Revision of Part 15 of the Commission's Rules to Permit
Unlicensed National Information Infrastructure (U-NII)
Devices in the 5 GHz Band

ET Docket No. 13-49

**REPLY COMMENTS OF
NCTA—THE INTERNET & TELEVISION ASSOCIATION
REGARDING THE OFFICE OF ENGINEERING AND TECHNOLOGY'S
REPORT ON PHASE I TESTING OF PROTOTYPE U-NII-4 DEVICES**

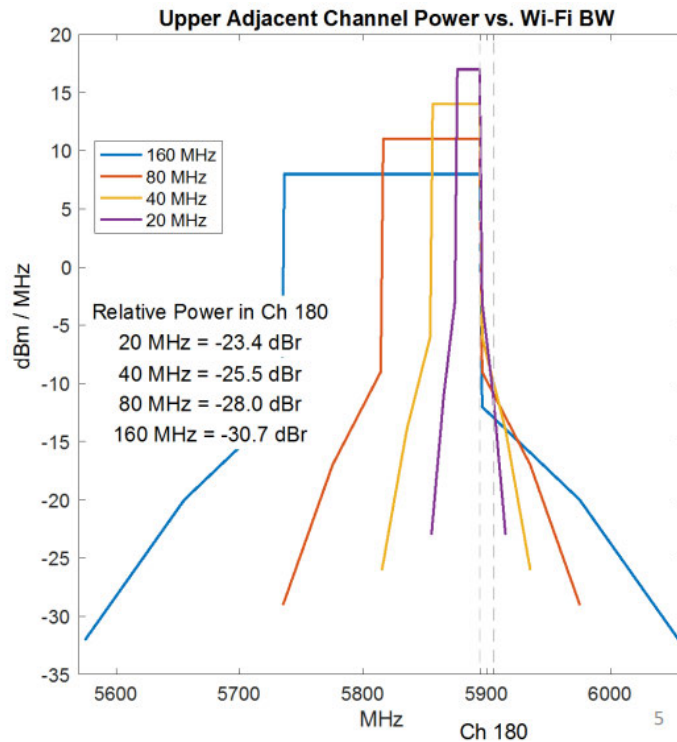
Some commenters suggest that further adjacent-channel testing is needed to evaluate devices operating in 40-, 80-, or 160-megahertz-wide channels, as opposed to the 20-megahertz-wide channels in OET’s testing, because “the interference characteristics” of these channels would be “different.”²⁸ More specifically, Toyota argues that “out-of-channel energy would be spread over a greater spectral range,” which may affect adjacent-channel interference results.²⁹ But the Commission has received information on this topic previously as well, and it is clear that wider channels would impart significantly *less* power into the first-adjacent channel than would a 20-megahertz channel.³⁰ That is because the same “total power restriction” applies regardless of the size of the channel, leading to lower power spectral density as channel size expands.³¹ In other words, as illustrated in the figure below from NCTA’s June 2017 letter,³² while Toyota is correct that out-of-band emissions reach farther under wider channelization, the impact on the channel most affected by those emissions—the first-adjacent channel—is diminished, and the power that reaches other nearby channels is even lower. Testing 20-megahertz channels was the most conservative choice OET could make.
